GISBORNE WASTEWATER NETWORK – OVERFLOW DISCHARGES: REGULATORY REF: DW-2020-109732-00/WD-2020-109733-00

Further S92 Response 21 April 2021

Pipe Height: 200.00

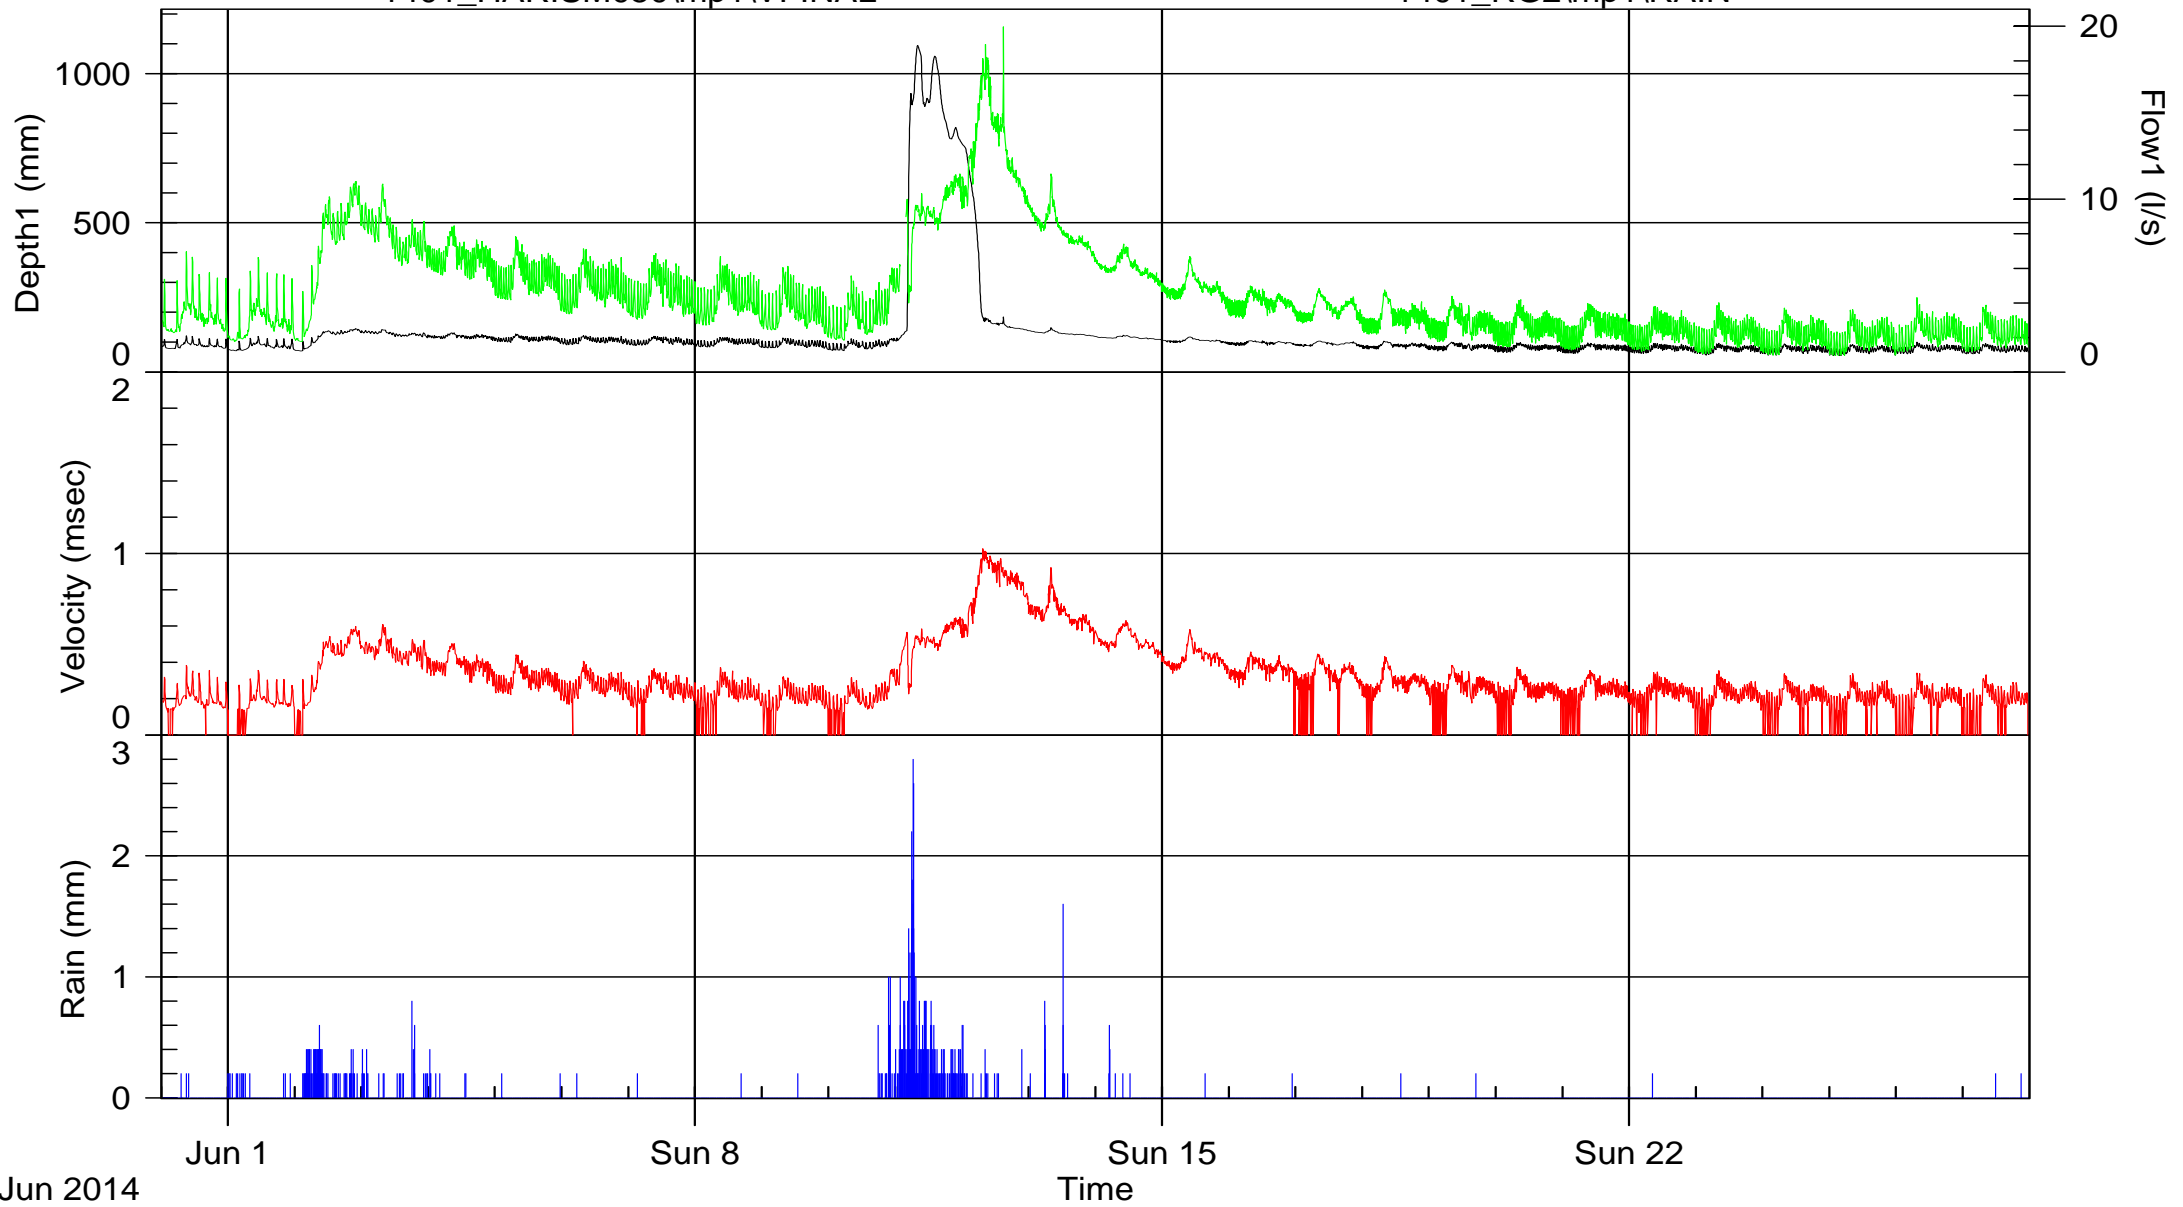
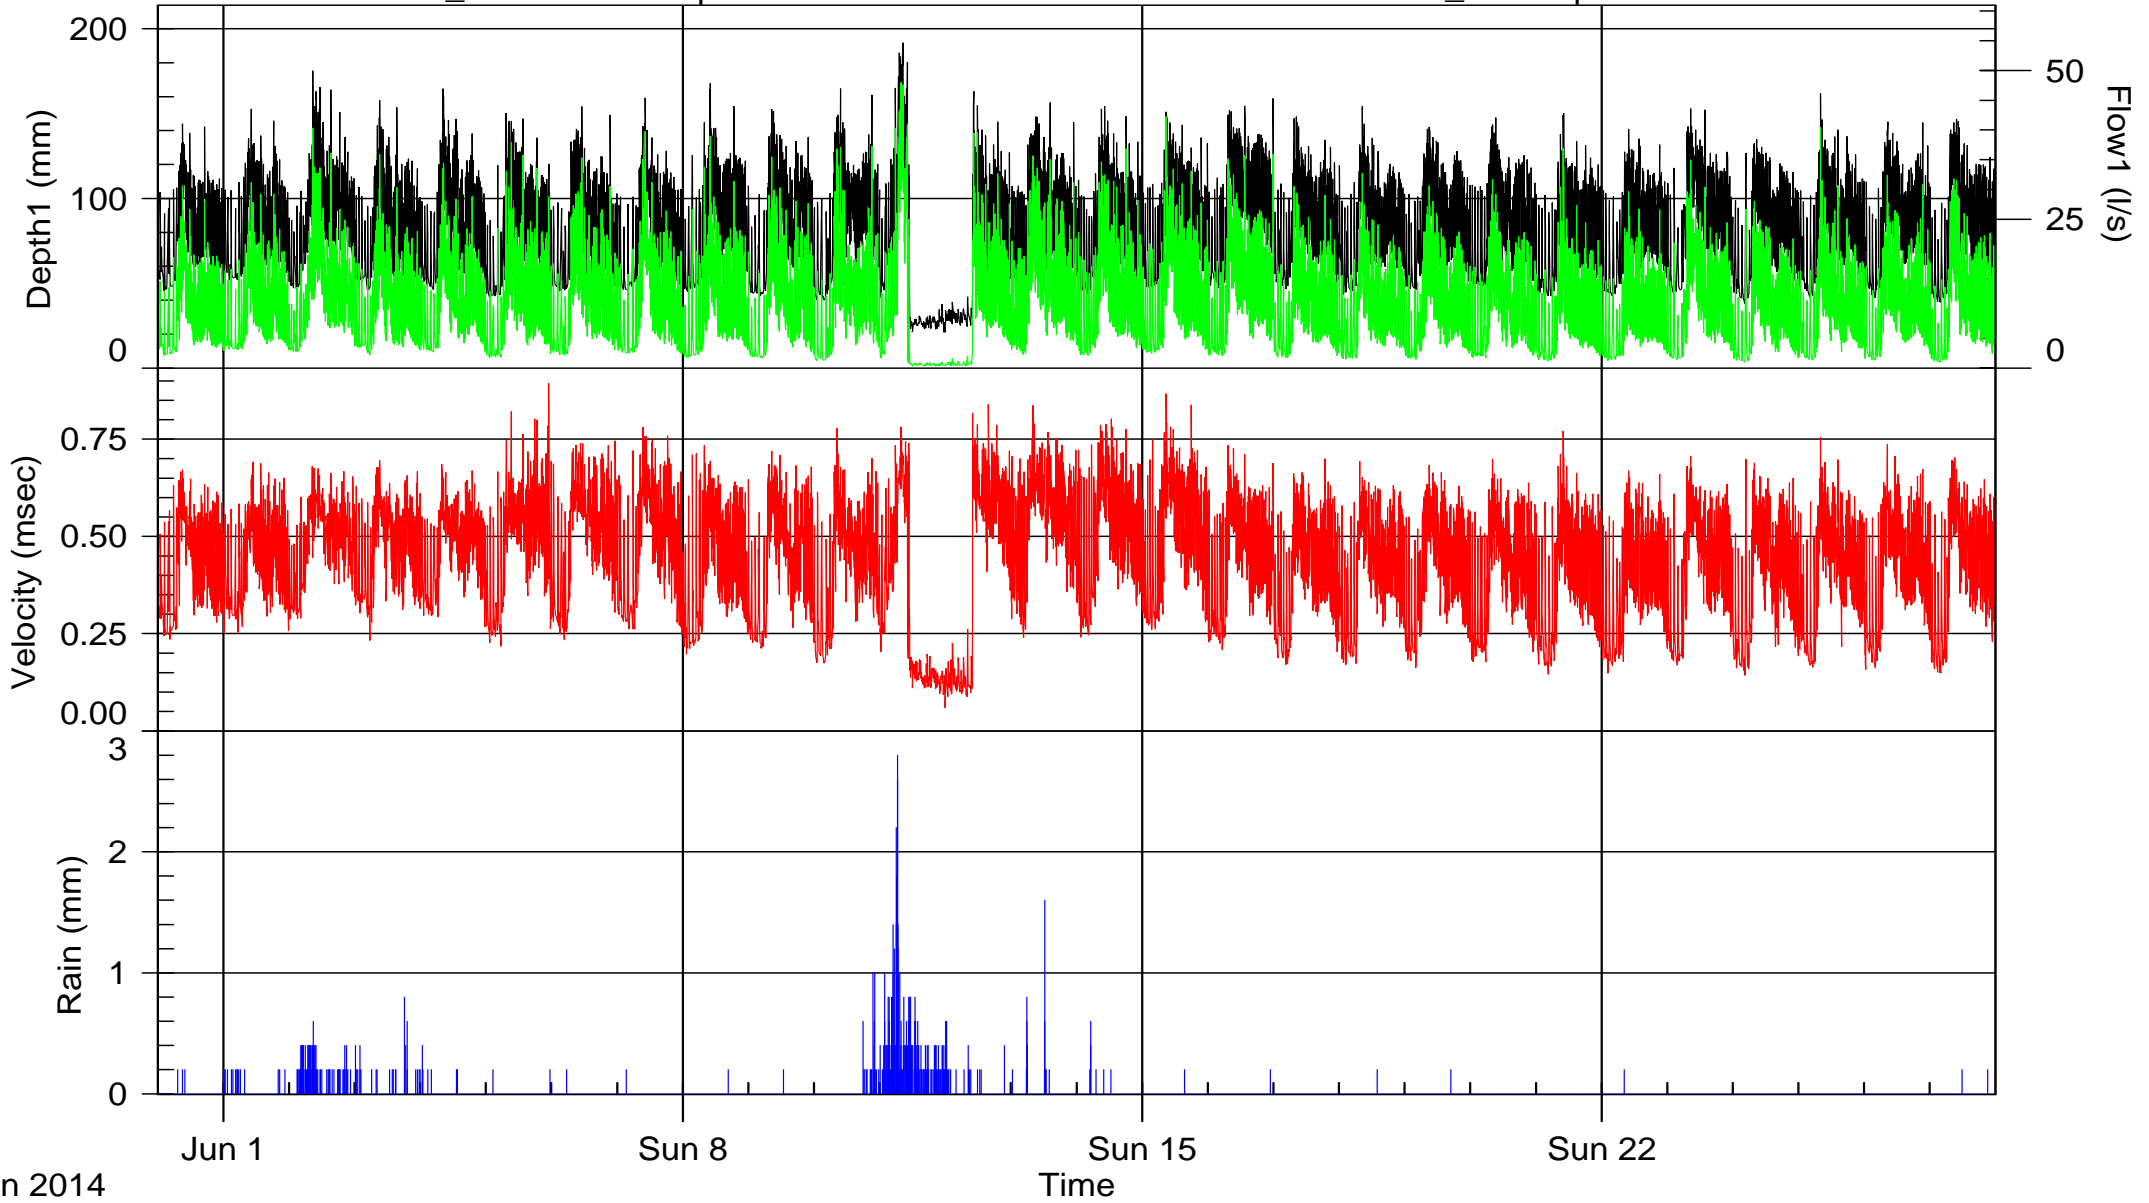
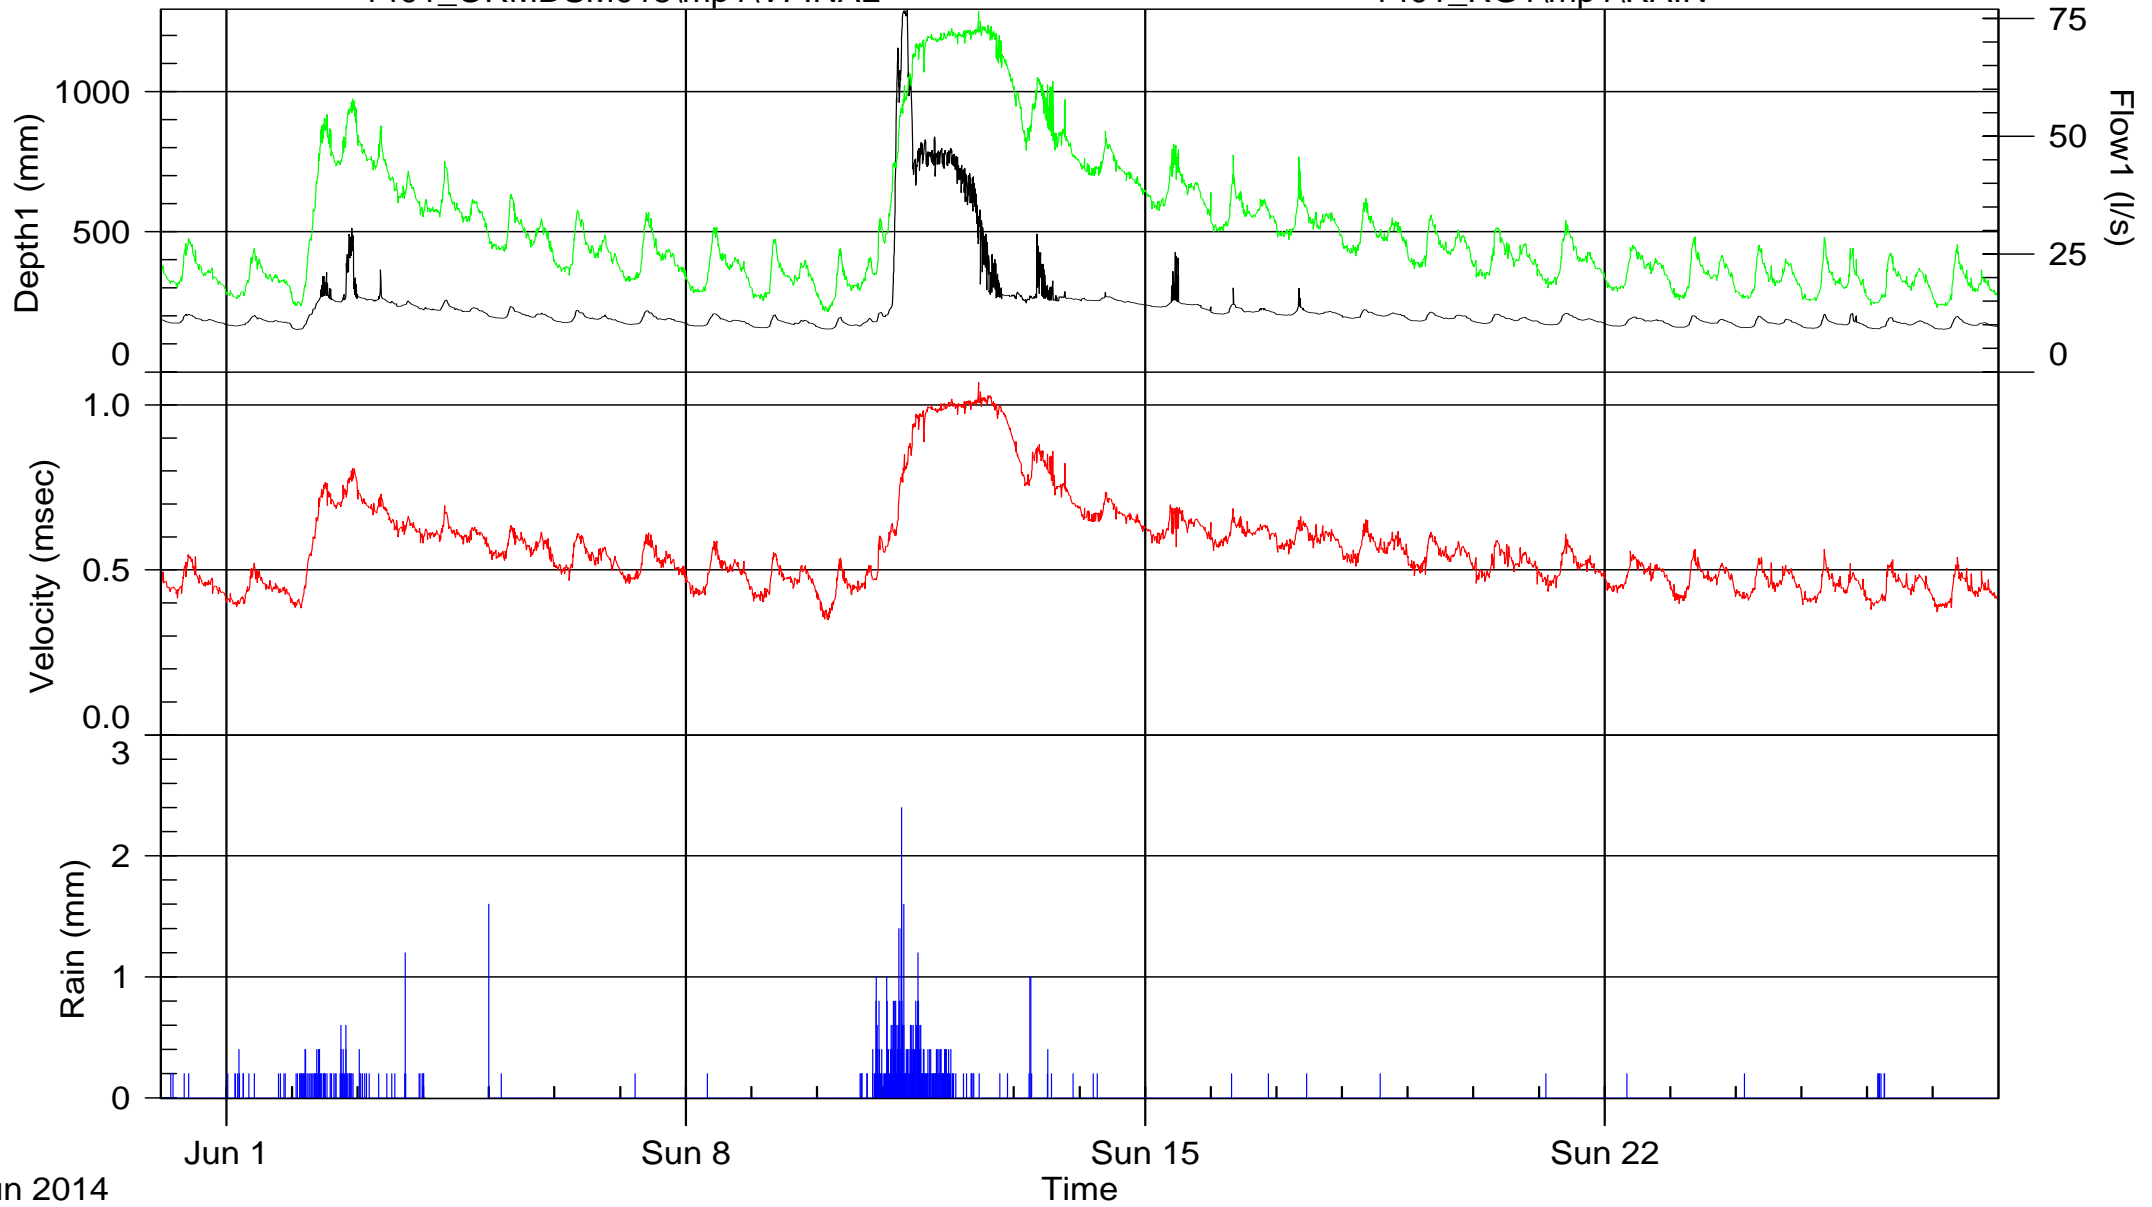
<p>upstream wastewater network including pump stations and reference (from the Mott Macdonald gauging report) which locations/hydrographs one(s) show the fast response to direct inflow?</p>	<p>We have also extracted flow monitoring information from the Mott Macdonald report for June 2014 (Attachment B) to facilitate review of the network flow monitoring across the monitoring sites. As can be seen from this extract, all of the monitoring sites show rapid response to heavy rainfall. Some sites to the south of the Taruheru River (eg APNISM135, DISRSM125 and LYTTSM075) also show the influence of overflow valves being opened from 11 to 12 June 2014.</p>
<p>b. Can the applicant provide a map/schematic that show areas of known property flooding referenced in the original application, page 223, see Figure 3-2 from the CH2M Beca Modelling Report, 2017. How does this compare to the nodes identified as flooding in the 2yr-ARI map (Figure B2) in the Beca modelling report.</p>	<p>A map showing indicative property ponding is provided below.</p> <p>The 'Ponding Likelihood' layer predicts where water is likely to pond on a property, based on a number of GIS layers that have been aggregated through a weighting process. These GIS layers include our stormwater flood model, depressions layer, and a Rain on Grid model.</p> <p>Ponding can be affected by many factors, e.g. fences on a property may divert flows, private stormwater sumps and pipes may drain areas, and soil conditions may allow for water to seep into the soil quicker than modelled. The data is also relevant to information available at a specific point in time, and things may have changed over time. Therefore, this layer is viewed as a guide only, as site conditions could be different.</p> <p>The modelled information is based on geospatial modelling, is for indicative purposes only. Council also uses records of actual flooding (surveys and Requests for Service received) and undertakes property inspections / investigations to validate whether or not there are actual effects, and whether or not stormwater drainage improvements (public or private) are required to mitigate the risk of ponding.</p> <p>The nodes identified in Figure B2 have been overlain on the Ponding Likelihood' layer. However, the location of property flooding in heavy rainfall will not necessarily correlate to the location of wastewater overflows from manholes.</p> <p>While property flooding is considered a primary cause of rainwater entering the wastewater system, properties that experience wastewater overflows will not necessarily also be the properties that experience rainwater flooding. Property</p>

<p>c. Can the applicant please provide a <u>model calibration report</u>. This should include a comparison between predicted/modelled flows and gauged data and demonstrate how well the model performs. This is required to determine the level of confidence in the modelling results (and subsequent conclusions).</p>	<p>No specific calibration report was produced. The flow gauge data and model graphs were part of the calibration process as is standard practice. The model aims to reflect the AWT flow gauging report that shows rainfall and the resultant wastewater flows that occur very quickly afterwards. As indicated in our previous response, the flow gauging sites were selected with a key aim of calibrating the model to predict overflow performance. The flow records show rapid and substantial increases in wastewater network flows associated with rainfall events and this is a clear demonstration of the result of direct stormwater inflow (Fast Response), which is replicated in the wastewater model.</p>
